Form 3160-5
(June 2019)

SUNDRY NOTICES AND REPORTS ON WELLS
Do not use this form for proposals to drill or to re-enter an abandoned well. Use Form 3160-3 (APD) for such proposals.

EOG respectfully requests an amendment to our approved APD for this well to reflect the following changes:

Ripple 32 Fed Com 730H (FKA Ross Draw 17 Fed Com 804H) API #: 30-015-48499

State of New Mexico
Energy, Minerals & Natural Resources Department
OIL CONSERVATION DIVISION
1220 South St. Francis Dr.
Santa Fe, New Mexico 87505

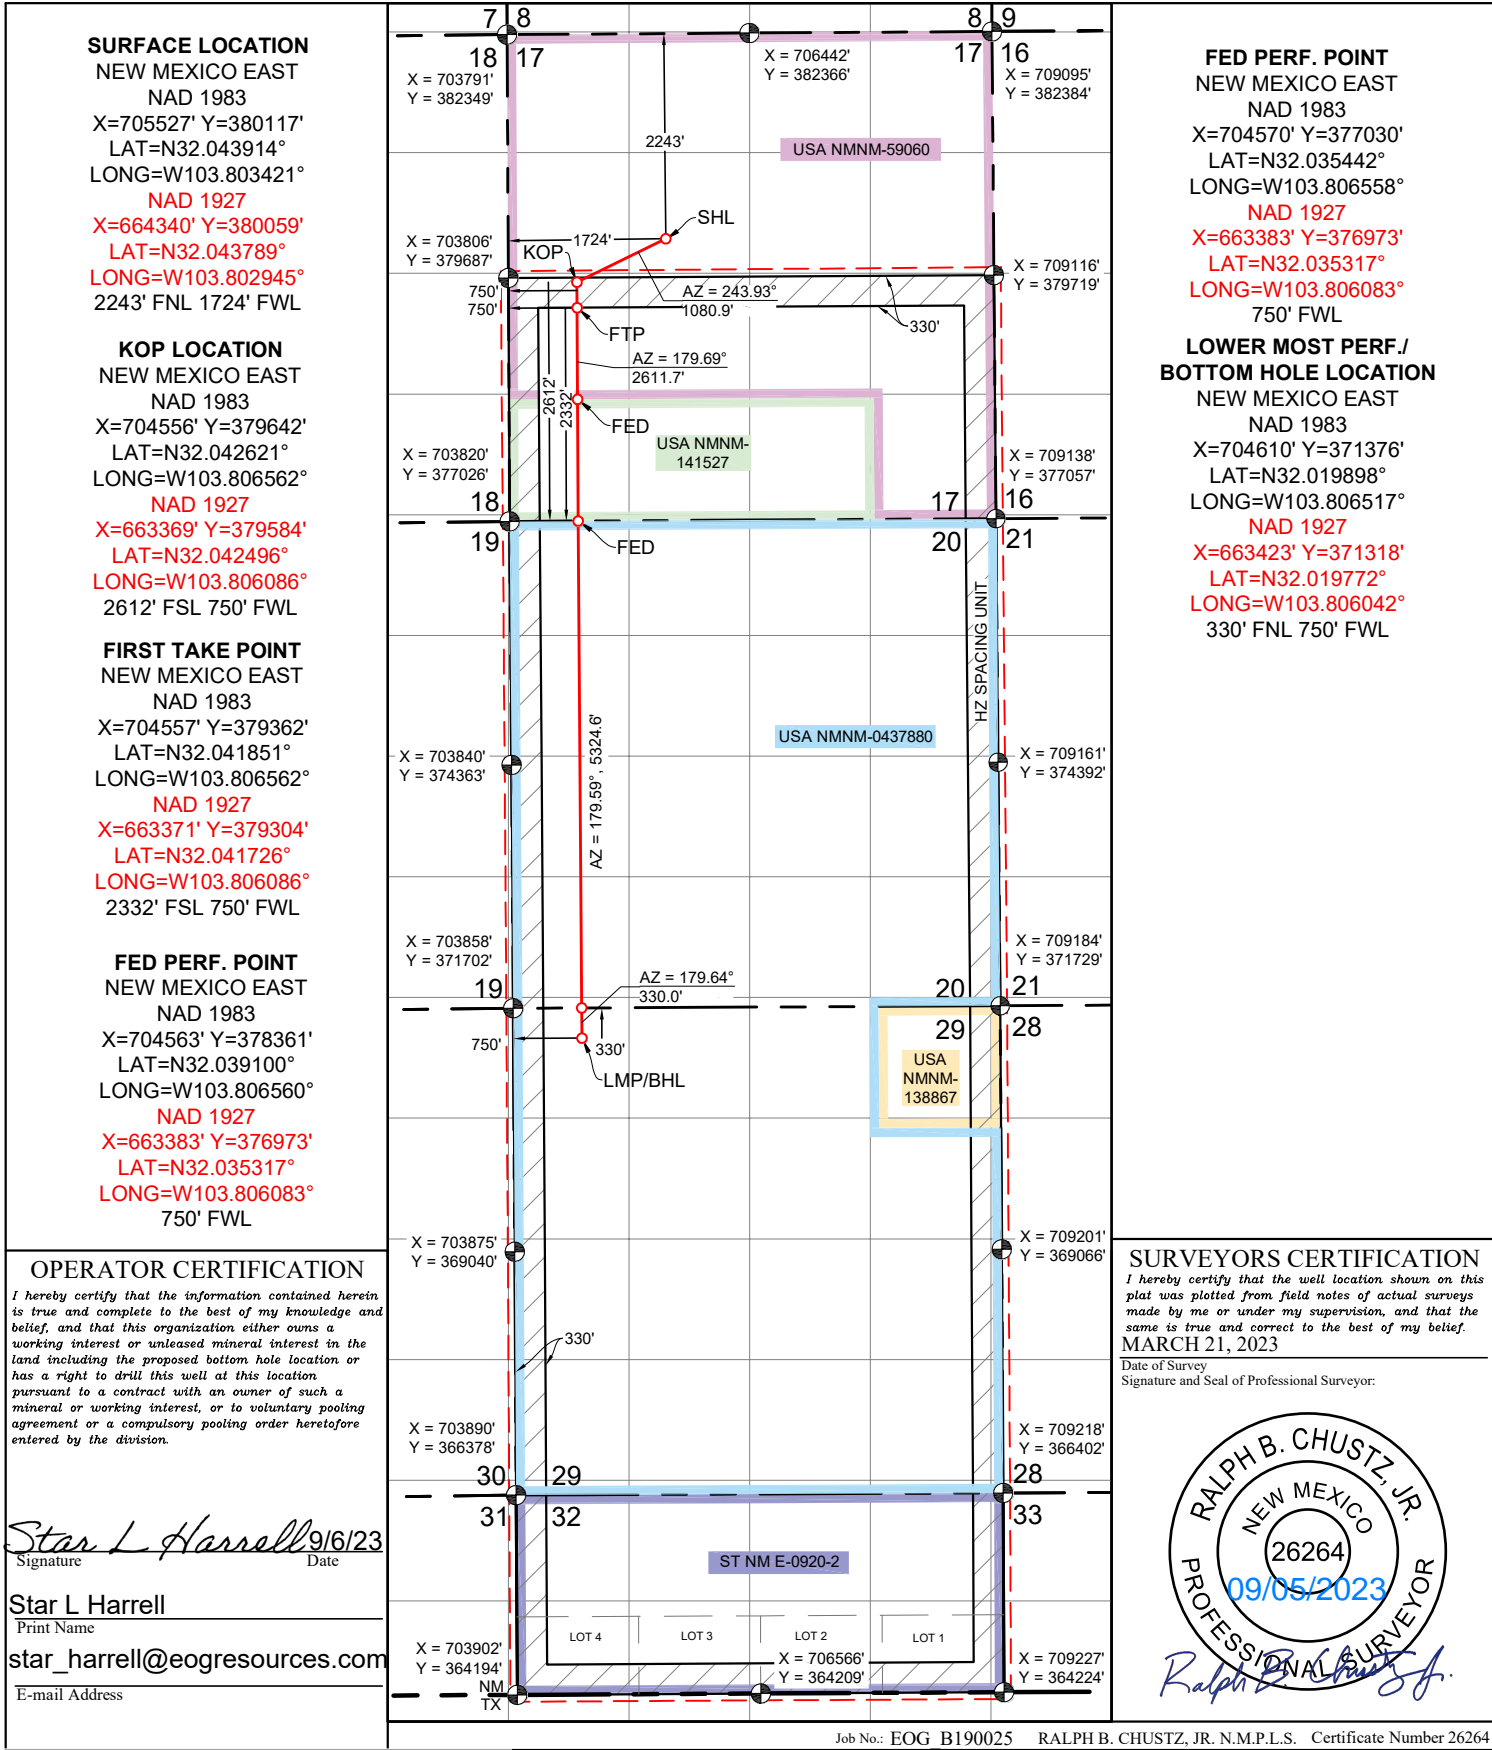
Change name from Ross Draw 17 Fed Com 804H to Ripple 32 Fed Com 730H.

Change BHL from T-26-S, R-31-E, Sec 8, 230' FNL, 1650' FWL, Eddy Co., NM, to T-26-S, R-31-E, Sec 29, 330' FNL, 750' FWL, Eddy Co., N.M.

Change target formation to Wolfcamp U2.

Update HSU to 1862 acres.

UL or lot no.	Section	Township	Range	Lot Idn	Feet from the	North/South line	Feet from the	East/West line	County
D	29	26 S	31 E		330	NORTH	750	WEST	EDDY

Dedicated Acres	Joint or Infill	Consolidated Code	Order No.
1862			PENDING NSP & PENDING COM AGREEMENT
